**BOARD ACTION REPORT – APPEALABLE ITEM**

**Project Name:** Alta Historic Delray  
**Project Location:** 225 Depot Avenue  
**Request:** Amendment to Master Sign Program  
**Board:** Site Plan Review and Appearance Board  
**Meeting Date:** February 22, 2017

## **CITY OF DELRAY BEACH ---STAFF REPORT---**

**ITEM:** Alta Delray Station (2017-081) – The item before the Board is to Amend the Master Sign Program for Alta Delray Station formally known as Depot Square located at 225 Depot Avenue pursuant to LDR Section 4.6.7(F)(2)(b).

MAIN ENTRY MONUMENT - SPECIFICATIONS

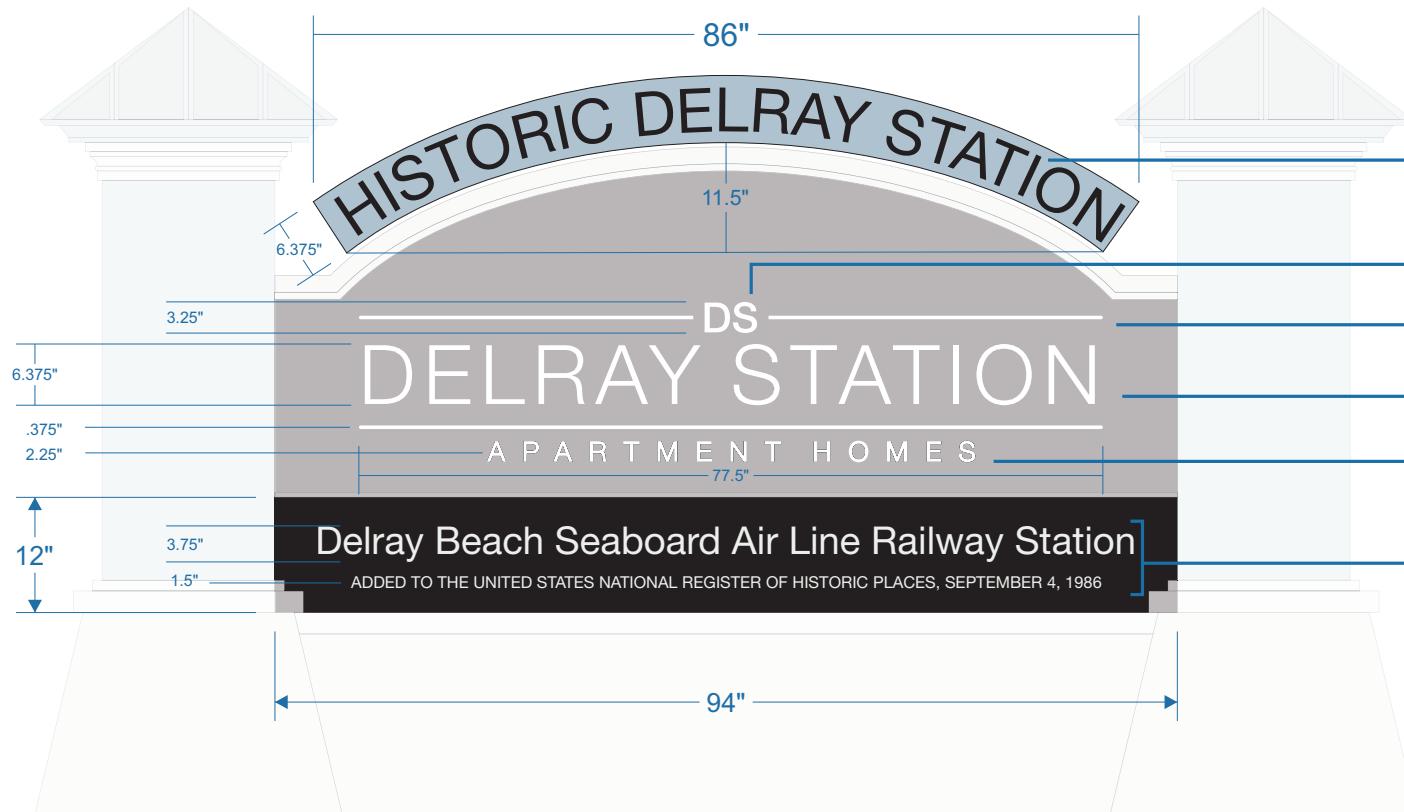
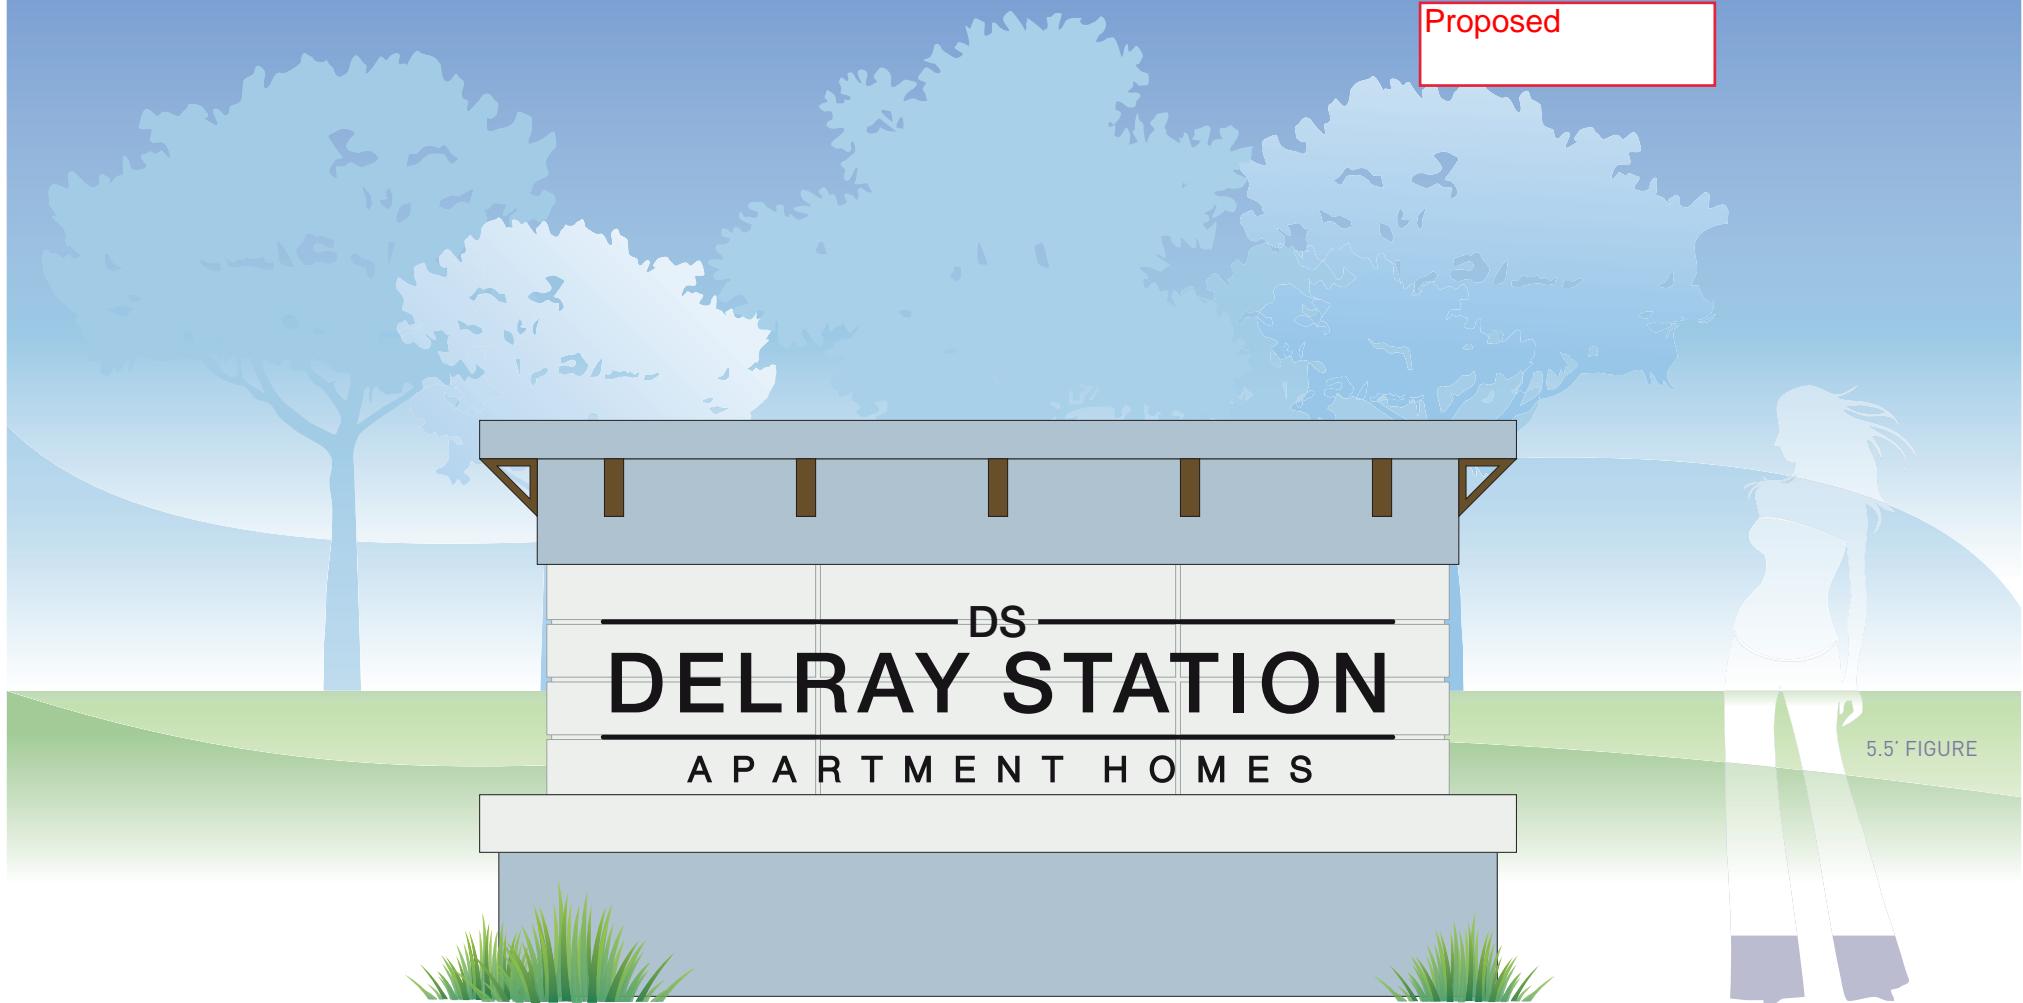
### **Monument Sign (Lake Ida Road and Depot Road)**

The location of the off premise sign at the southwest corner of Lake Ida Road and Depot Avenue will remain the same as it was approved by the City Commission by a waiver request at its meeting of September 16, 2014. The monument sign is 7' height with a sign area of 3.83' x 7.8' for a total of 29.64'. The sign is double sided in a honest blue, extra white and black lettering and reads "Historic Delray Station, Delray Station Apartment Homes, Delray Beach

Staff has no concerns with the monument signs as the placement of the signs have not changed from the original approval. The size of the signs is approximately the same size and the colors are compatible with the surrounding neighborhood. The only change in the wall sign is that the applicant has elected two lines of copy instead of one. As previously noted, the size of the sign is slightly reduced. Staff recommends that a revision to the previously approved copy for the purpose of consistency when referring to the train depot's historic designation which would be "Listed on the National Register of Historic Places on September 4, 1986."

Based on the above, positive findings can be made with respect to LDR Section 4.6.7(F)(2)(b) to amend the Master Sign Program for Alta Delray Station located at 225 Depot Avenue, as proposed with the suggested copy revision.

#### ROUND-A-BOUT MONUMENT - PREVIEW

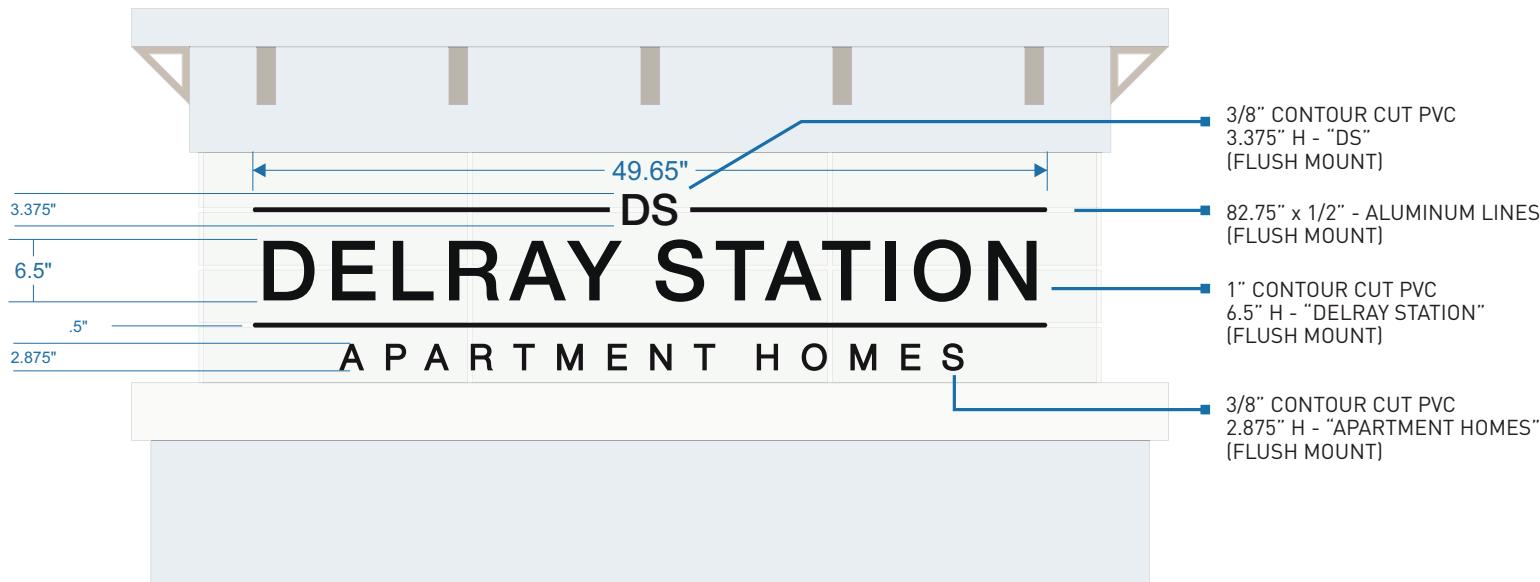
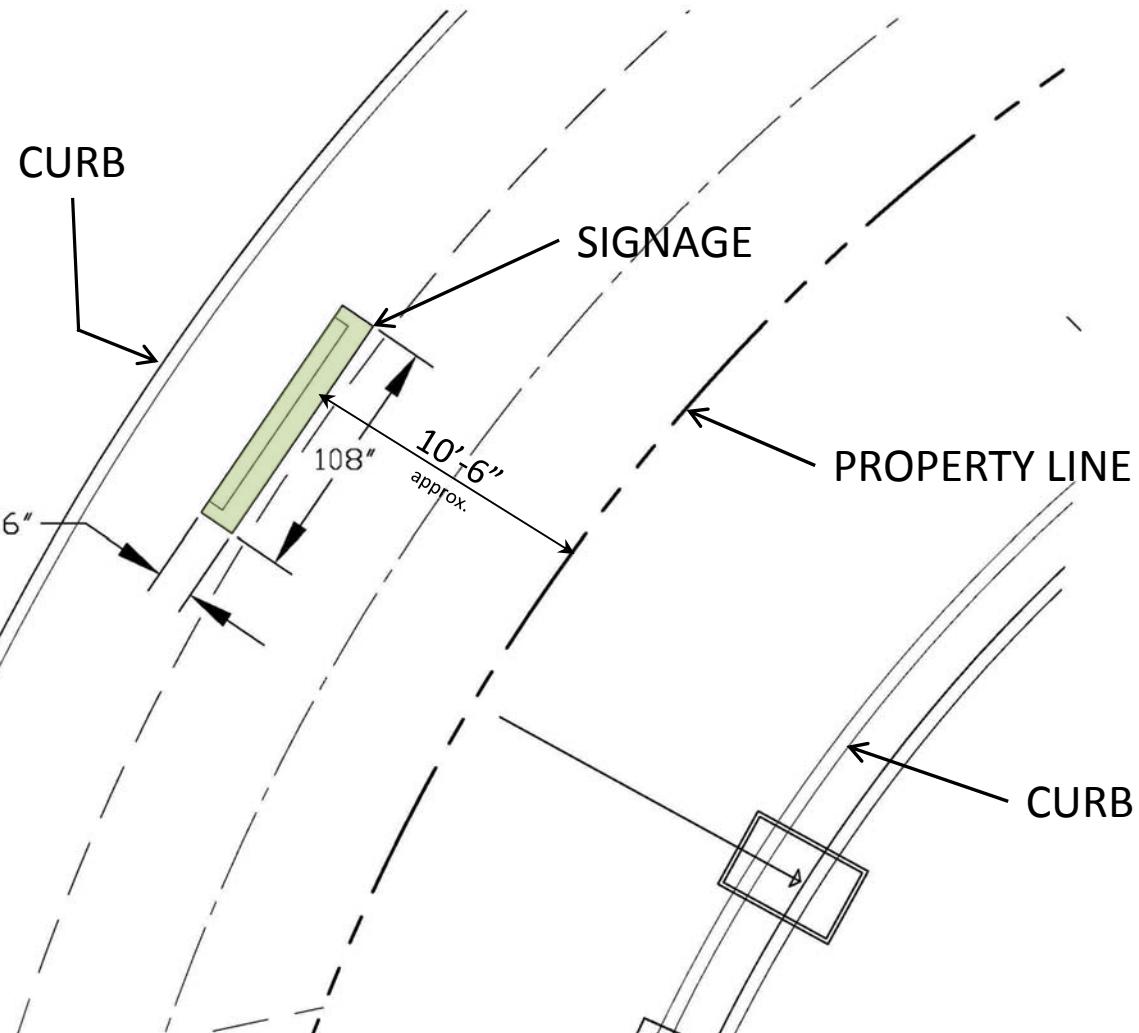
### **Entry Feature Monument Sign**

The monument sign is 5' in height with a sign area of 1.39' x 7.75' for a total of 10.77' square feet. The sign is double sided in honest blue, umber, white and black lettering. The sign is located at the entrance roundabout in a landscaped curbed area.

#### CHANNEL LETTERS - SPECIFICATIONS

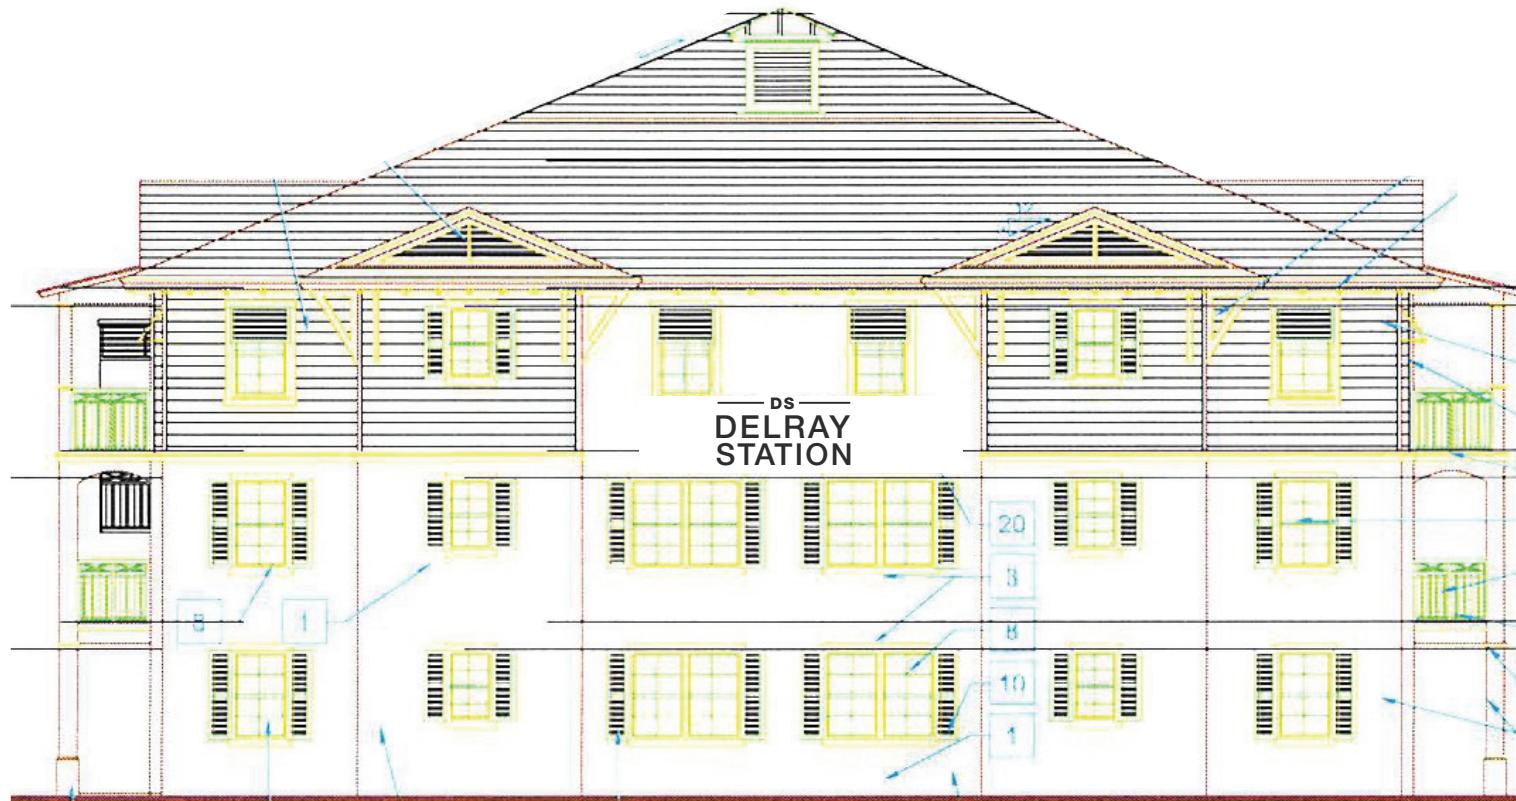
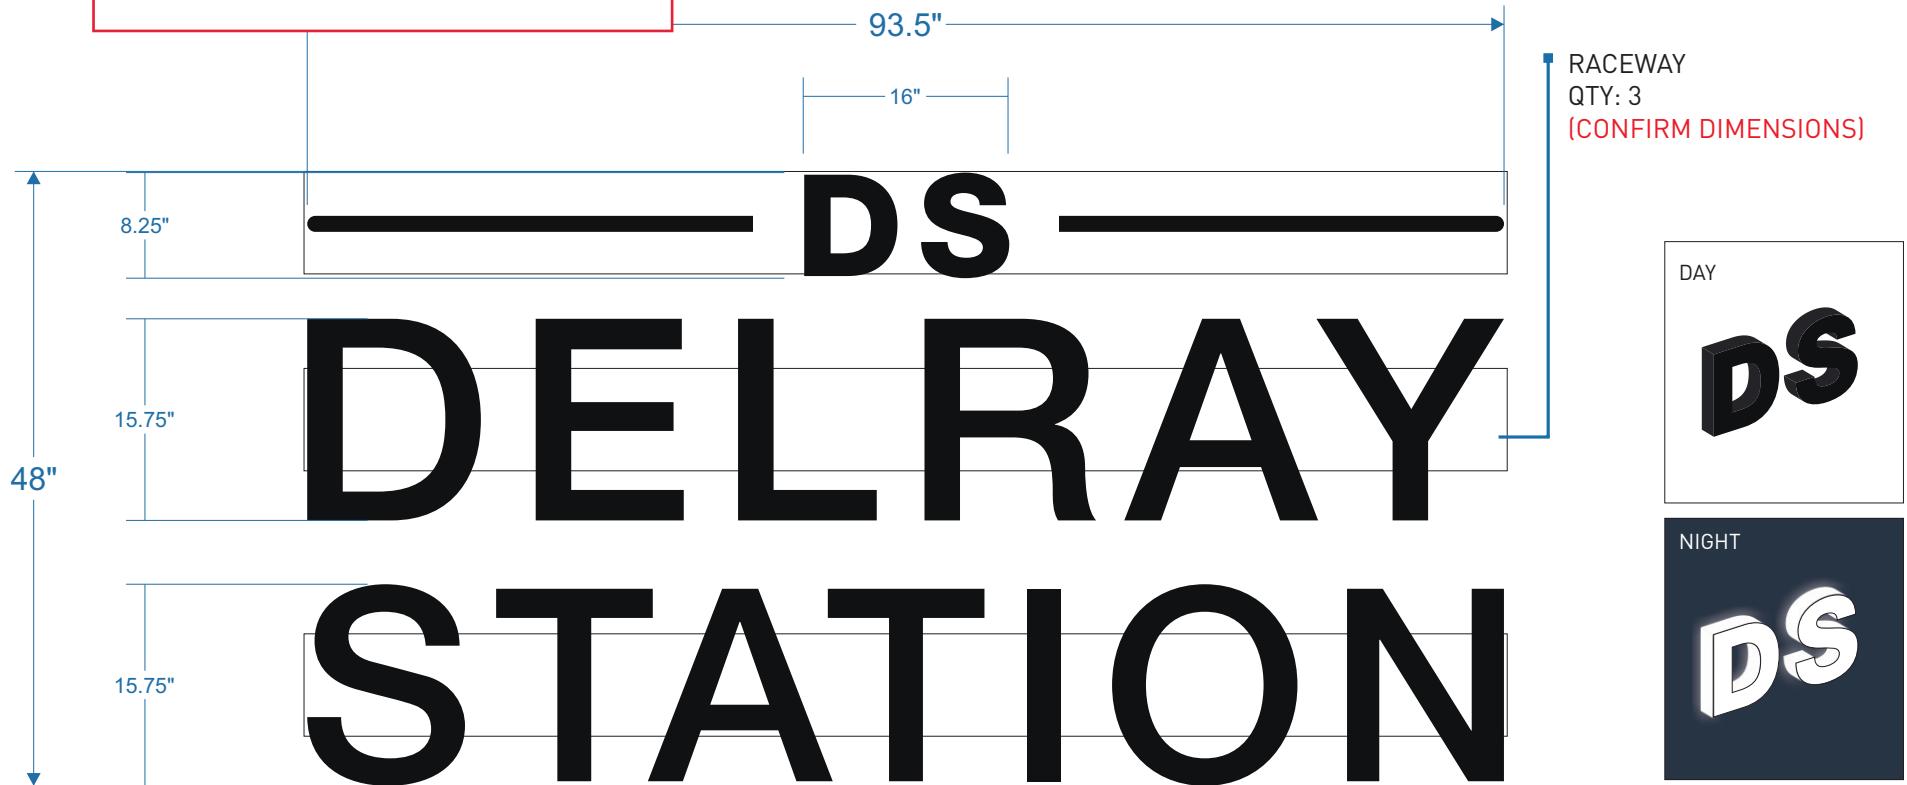
### Wall Sign

The wall sign will remain on building five on the east elevation facing I-95 between the second and 3<sup>rd</sup> level and is LED illuminated raceway mounted black channel letters. The sign is two lines of copy 4' x 7.79' for a total of 31.16 square feet. Staff supports the new design and reduction of the wall sign.
